Project	IEEE 802.16 Broadband Wireless Access Working Group < http://ieee802.org/16 >	
Title	Text for Annex on Coordinated Coexistence with 802.11	
Date Submitted	2008-01-15	
Source(s)	Mariana Goldhamer Alvarion ltd. 21A, Ha Barzel Street Tel Aviv	E-mail: mariana.goldhamer@alvarion.com
Re:	LB 29	
Abstract		
Purpose	[Description of what <i>specific</i> action is requested of the 802.16 Working Group or subgroup.]	
Notice	<i>This document does not represent the agreed views of the IEEE 802.16 Working Group or any of its subgroups. It represents only the views of the participants listed in the "Source(s)" field above. It is offered as a basis for discussion. It is not binding on the contributor(s), who reserve(s) the right to add, amend or withdraw material contained herein.</i>	
Release	The contributor grants a free, irrevocable license to the IEEE to incorporate material contained in this contribution, and any modifications thereof, in the creation of an IEEE Standards publication; to copyright in the IEEE's name any IEEE Standards publication even though it may include portions of this contribution; and at the IEEE's sole discretion to permit others to reproduce in whole or in part

Figure hB-1 The relationship between the 802.11 quiet intervals and the CX-Frame

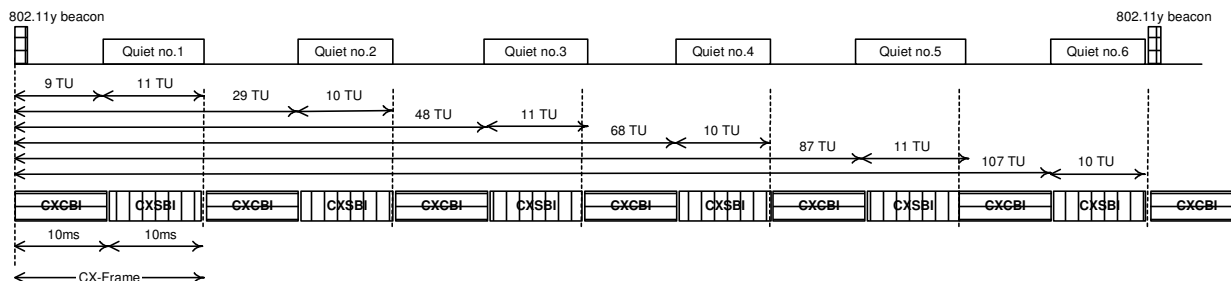
Quiet intervals are scheduled so as to not overlap with the CXCBI intervals and to leave the start of the CXCBI for 802.11 base station downlink transmission. (11.9.2 *Quieting channels for testing*, and 7.3.2.23 *Quiet Element* [4]). The Quiet Elements should use the following parameters:

The quiet intervals related to the CX-Frame are shown in Figure **hB-1hB-1**.
